PORTLAND PLANNING BOARD MEETING

Re: **September 13th 2016 Planning Board Workshop**
Level III Site Plan and Subdivision:
54 unit residential development, 75 Chestnut Street
A&M Partners Inc, Applicant

75 Chestnut Street- Preliminary Site Plan Review Comments

Existing Conditions and Demolition (Plan P2)

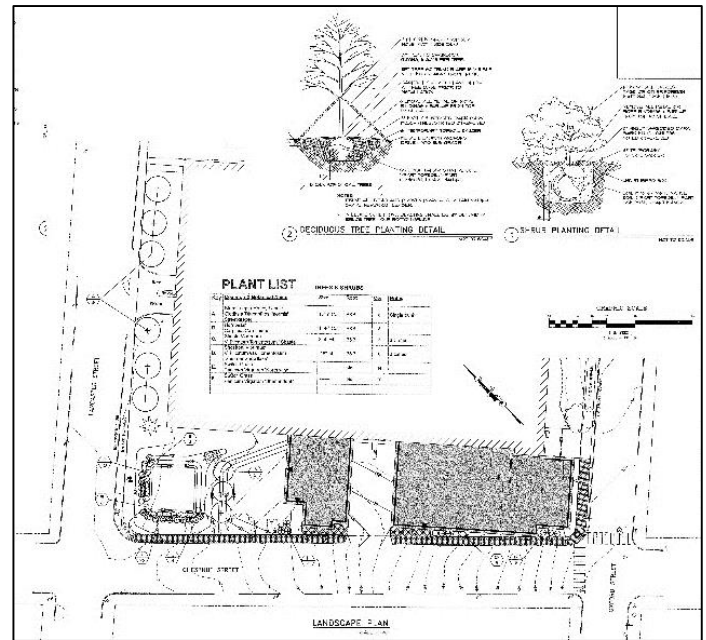
The proposal results in the removal of 7 of the 10 mature trees at the back of the sidewalk on Chestnut Street (Plan P2). The Landscape Plan does not replace these trees along that frontage, though adds 9 new trees on the site. The issue of street tree provision would need to be addressed in the final submission.

The "Existing Conditions & Demolition Plan" ([Plan P2](#) and below) shows that 7 of the 10 existing mature trees along Chestnut Street would be removed. The Landscape Plan ([Plan P6](#) and below) does not suggest any replacement for these mature trees. Staff suggest that the Landscape Plan requires further consideration.

Initial submitted Elevations

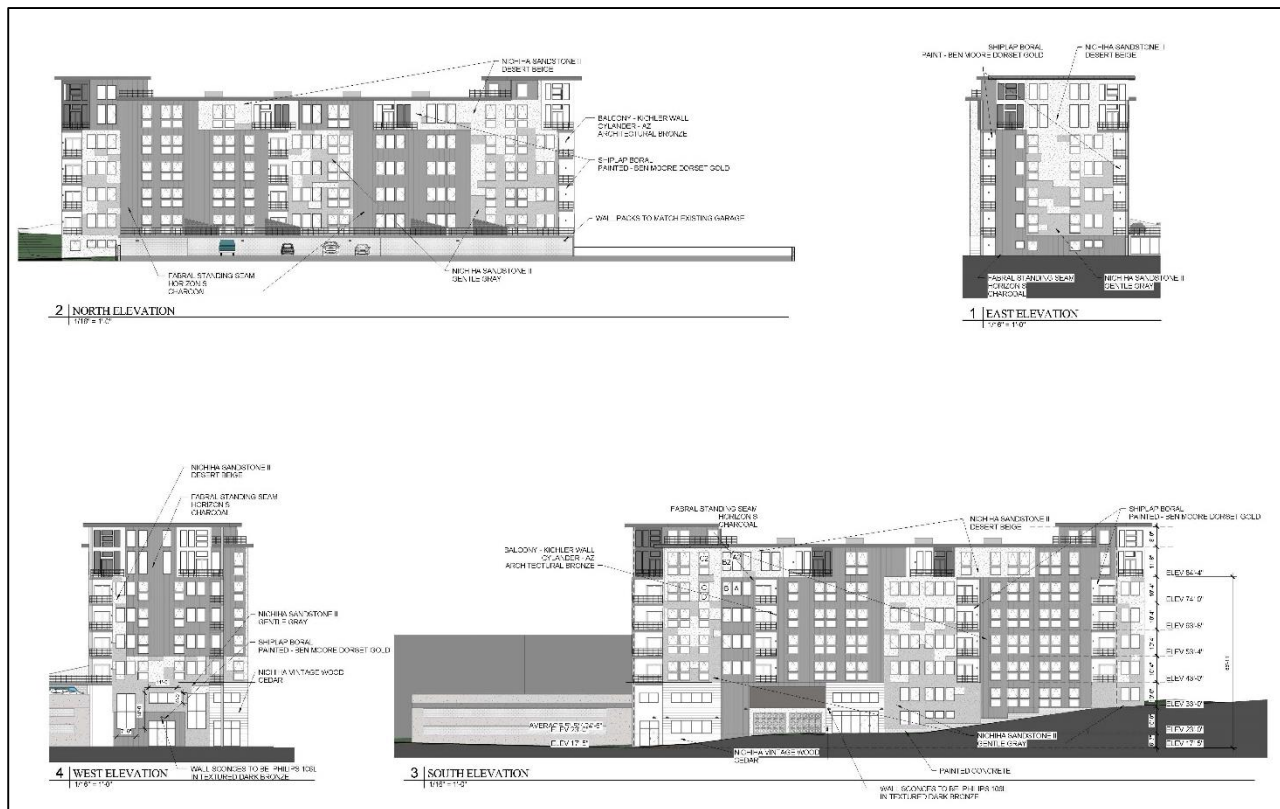
- E1 Architectural Design: There are a few areas of concern where residential unit windows facing public rights-of-way are low to the ground and do not provide visual privacy for the occupants. The driveway to the garage from Chestnut Street will need further detail to address safety concerns - it should not become a dark tunnel.*

- E10 Rooftop Appurtenances: Will there be rooftop appurtenances? Where will they be and how will they be screened?*
- E12 : Materials: The guidelines currently prohibit fiber cement panels to be used on portions of the building visible from the public rights of way. Either revise the material selection to comply with the standard or request a waiver from the Planning Board. In addition, the use of two different color panels in a pixilated manner is not necessary and adds visual distraction to an already visually complex facade.*

The applicant has responded to these comments ([Att. M](#)) by confirming that the windows have been revised, with windows added to the “blank” wall (see revised elevations and rendering below) and that the materials will be reviewed at the PB Workshop. Several other revisions have also been made eg the roofline.
